# Access Compliance Report

## Public Rights-of-Way

### (Curb Ramps)

Intersection ID: 26774	Main Street: ALEXA_RD	Cross Street: RATTERSLY_CT	Location: W
ADA ID: 5B3BB96B62BF	Ramp Type: BlendTrans1	Initial Pass/Fail: Fail	Overall Compliance: No
Severity Score: 10			
Codes/Mitigation Info/Possible Solution		Field Measurements/Component Compliance

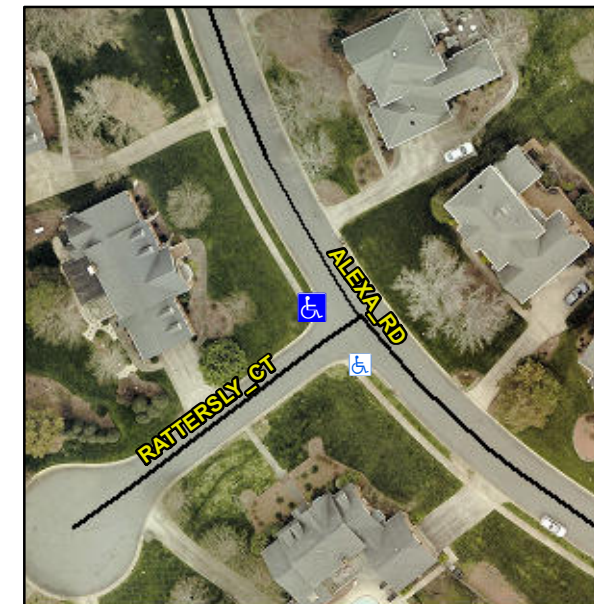
**R304.5.1, R304.5.3**

Compliance	Description	Data	Compliance	Description	Data
N/A	Ramp Length (in)	77.0	Yes	BlendTrans Slope (%)	3.2
No	Ramp Width (in)	41.0	No	BlendTrans XSlope (%)	3.2
N/A	Flare Type LT	N/A	N/A	Flare Type RT	N/A
N/A	Flare Slope LT (%)	N/A	N/A	Flare Slope RT (%)	N/A
N/A	Flare Traversable LT?	N/A	N/A	Flare Traversable RT?	N/A
N/A	Landing Length (in)	N/A	N/A	DWS Provided?	N/A
N/A	Landing Width (in)	N/A	N/A	DWS Contrast?	N/A
N/A	Landing Slope (%)	N/A	N/A	DWS Length (in)	N/A
N/A	Landing X Slope (%)	N/A	N/A	DWS Full Width?	N/A
N/A	Landing Curb? (Y/N)	N/A	N/A	DWS Offset (in)	N/A
N/A	Shared Landing?	N/A			
N/A	Gutter Ponding?	N/A	N/A	Gutter Slope (%)	N/A
N/A	Gutter Lip Ht (in)	N/A	N/A	Gutter X Slope (%)	N/A
N/A	Painted X Walk1?	No	N/A	Painted X Walk2?	No
	X Walk 1 Direction	To SE		X Walk 2 Direction	To NE
	X Walk 1 Width (in)	N/A		X Walk 2 Width (in)	N/A
	X Walk 1 Slope (%)	2.4		X Walk 2 Slope (%)	1.4
	X Walk 1 X Slope (%)	1.0		X Walk 2 X Slope (%)	2.9

**Remove & Replace Curb Ramp With Two New Directional Ramps or Equivalent.**
